**CALIFORNIA COASTAL COMMISSION**

**F 6d****STAFF REPORT AND RECOMMENDATION****ON CONSISTENCY DETERMINATION**

Consistency Determination No.	CD-087-03
Staff:	JRR-SF
File Date:	9/8/2003
60th Day:	11/7/2003
75th Day:	11/22/2003
Commission Meeting:	11/7/2003

Construction of an in-water grade-control structure to protect an existing bridge to the South Orange County Wastewater Treatment Plant (Exhibit 2 and 3)

EXHIBIT NO. 2  
 APPLICATION NO. CD-087-03  
 California Coastal Commission

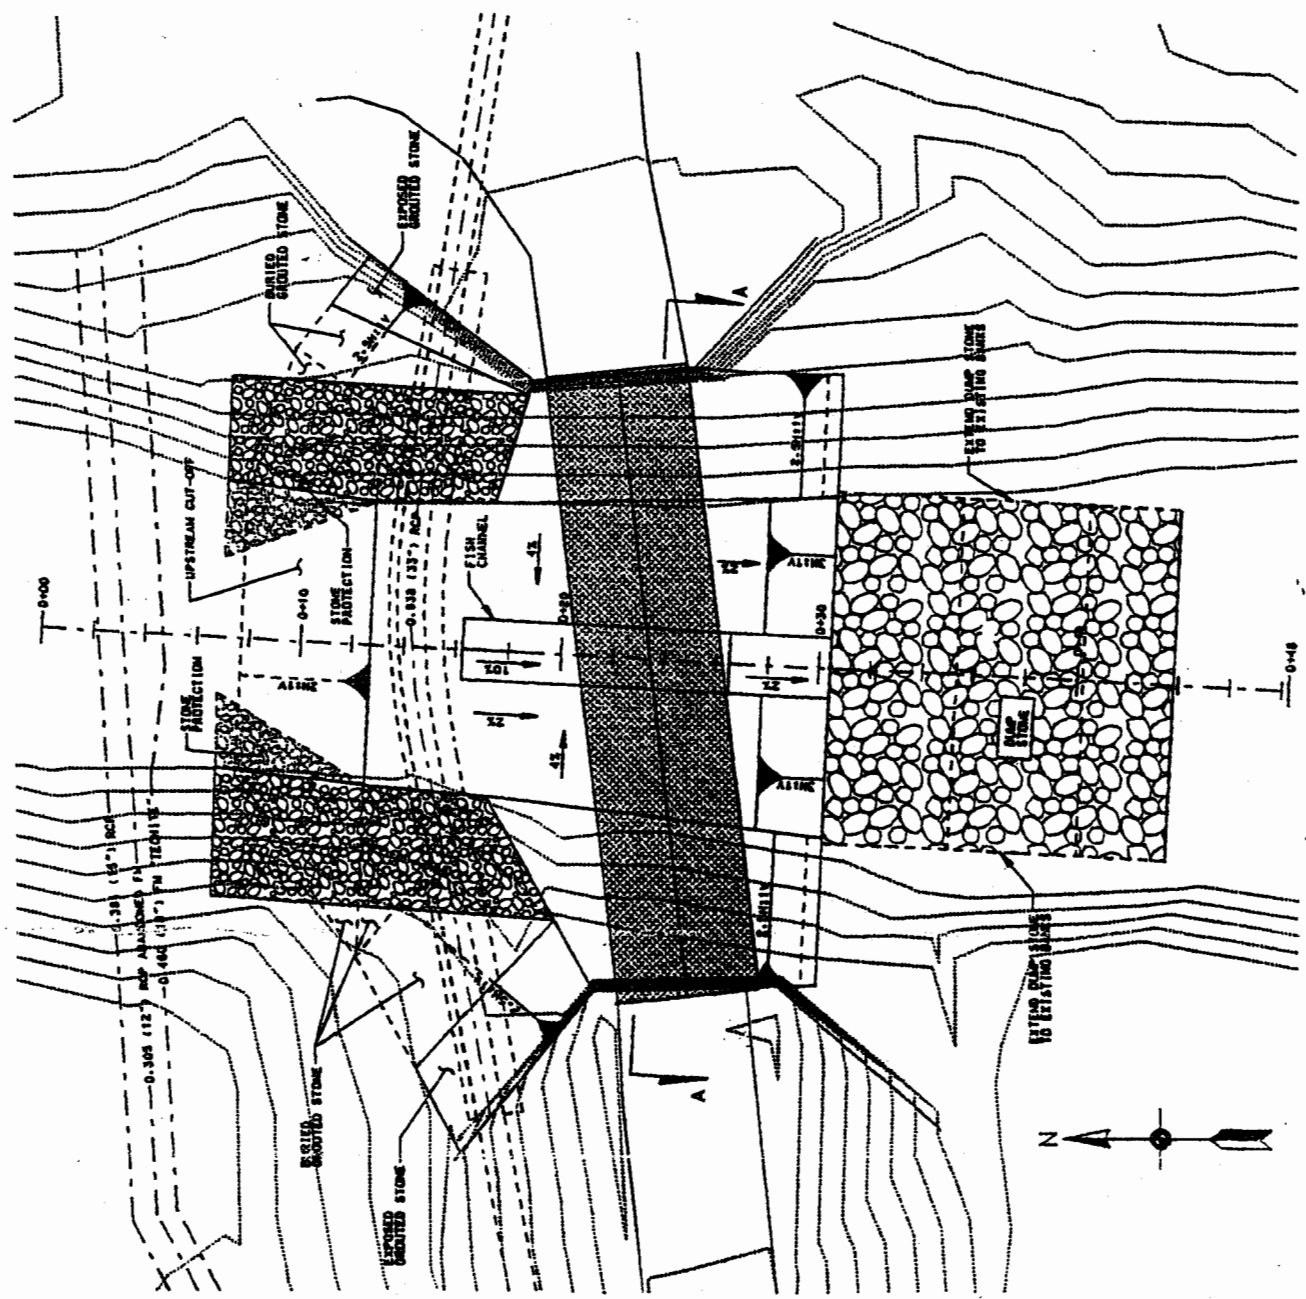
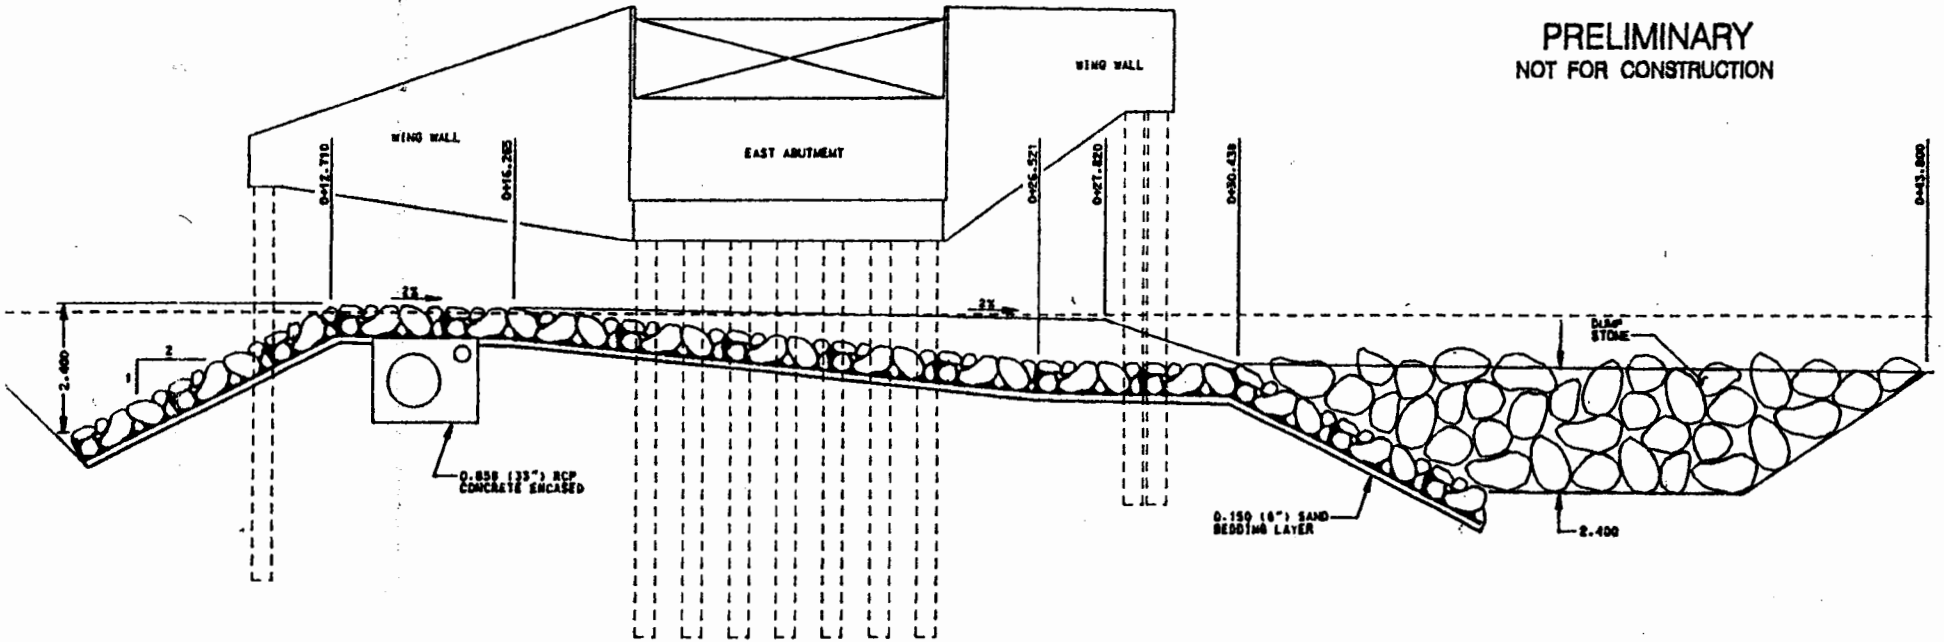
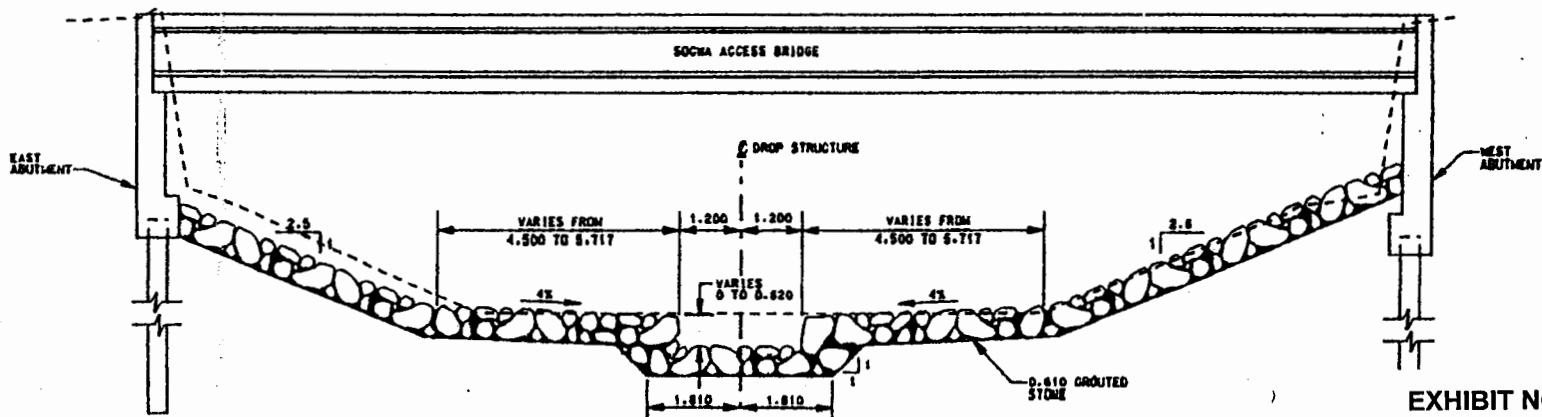
As described above, erosion caused by the stream threatens the bridge pilings. The Corps evaluated four alternative projects, the no-project alternative and three different grade-control structures. It did not consider any alternative to protect the bridge that did not result in significantly altering the stream. Not only is such an analysis necessary for the Commission to find the project consistent with Sections 30233 and 30236, the Commission has concerns about the effectiveness of the proposed project. In a document published by the San Francisco Bay Region, California Regional Water Quality Control Board, that agency raises concerns about this type of project. That document states that:

After initially reviewing this consistency determination, the Commission staff requested that the Corps consider lengthening the bridge as a way to reduce the need for substantial and permanent alterations to the stream. The Corps verbally responded by stating that such an alternative is too expensive and more damaging. In addition, the Corps provided a brief written discussion of this alternative supporting its conclusions (Exhibit 5). This document states that the a longer bridge would cost five times the cost of the proposed project, \$400,000, and would have two to three times the aerial extent of disturbance from the proposed project.

However, the additional information submitted by the Corps does not provide any supporting information to document this conclusion. There is no engineering analysis or factual documentation to support these conclusions. This additional information is insufficient for the Commission to find that the suggested alternative is either not feasible or more environmentally damaging. The unsupported conclusion that the project is five times as expensive as the proposed project does not allow the Commission to evaluate the feasibility of this alternative. Even if the Corps provides documentation to support the conclusion that the project costs \$2,000,000 (five times \$400,000), it would not demonstrate that such an alternative would be infeasible. In order for the Commission to conclude that the longer bridge alternative is infeasible, it would have to find that the added cost prevents the Corps from implementing the alternative. The Corps has not provided any information, other than the added cost, that would provide a basis for the Commission to find that the longer bridge alternative is infeasible.

Similar to the Corps economic analysis of this alternative, the Corps has not provided supporting information that documents its conclusion. However, even if the aerial extent of the longer bridge is greater than the proposed project, it may have less environmental impacts. The habitat maps (Exhibit 6) provided in the final environmental assessment indicate that the area on either side of the bridge contains disturbed habitat. On the treatment plant side of the bridge, the area is developed and on the other side of the bridge, the habitat consists of disturbed grasslands. Thus, it appears that even if the aerial disturbance is greater, the project may have less habitat effects.

In conclusion, from the information provided by the Corps, the Commission cannot determine if the project meets the alternative tests of Sections 30233 and 30236 of the Coastal Act. Therefore, the Commission finds that the Corps' consistency determination lacks sufficient information to determine that the proposed project is the least environmentally damaging feasible alternative.
